| APPLICATION NO. | FILING DATE | FIRST NAMED INVENTOR | ATTORNEY DOCKET NO. | CONFIRMATION NO. |
|--|-------------|----------------------|---------------------|------------------|
| 10/576,793 | 11/06/2006 | Laurent-Yves Grand | 1200.750 | 5852 |

Office Action Summary

2. Claims 1-9 are rejected under 35 U.S.C. 102(b) as being anticipated by Young et al. (US Patent No. 4,528,470).

Applicant's Arguments

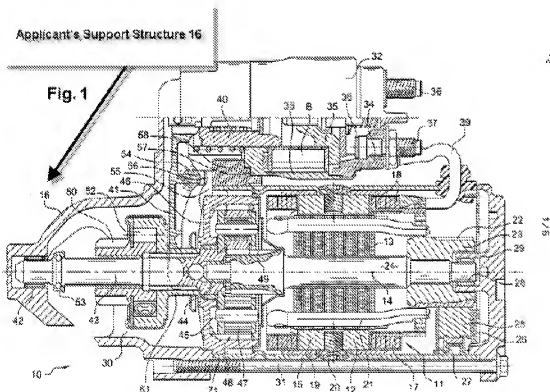
Applicant has amended the claims to further included that the support is a **permanent** fixture.

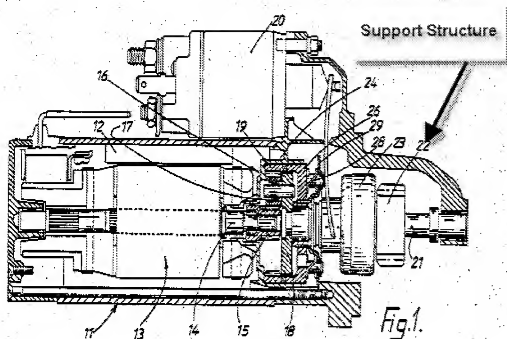
The support structure that Applicant has claimed is clearly shown in Figure 1 from Young (US Patent No. 4,528,470). As shown below, Applicant's support structure is denoted by item 16.

In Young's Patent (US Patent No. 4,528,470), Figure 1 clearly shows the support structure. Applicant is reminded to see MPEP 2125.
